Development Management – Delegated Officer Report

Application Number: AWDM/1150/24 Recommendation: APPROVE

Proposal: AWDM/1150/24 Approval of Details Reserved by Condition 8 (Levels) of Application No AWDM/0786/23.

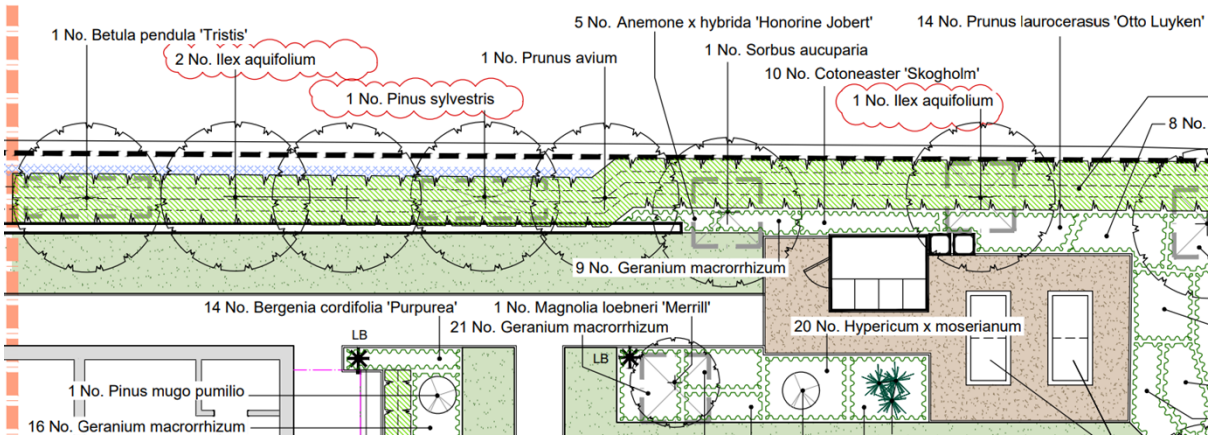
During the consideration of the outline application it was apparent that there would need to be an alteration of site levels to address drainage on the site. The site was lower in the NE corner of the site and to avoid pumps and ensure a gravity system levels on the site would need to be increased to ensure an appropriate fall to the south (and connection to existing foul / SW sewers).

'The applicant's drainage consultant explains that the drainage design uses a gravity fed system which does not require pumps. This is as a direct result of Council policy which favour pumpless systems and is part of the approved drainage strategy. As a result the levels' design has to tie-in to the existing drainage levels in Barrington Road to the south, with sufficient gradients to allow internal flows within the pipes and manholes.

The technical note comments: 'As such the Levels design must match or exceed the level changes in the drainage design'.

The discharge of the levels condition No 8 is therefore considered acceptable.
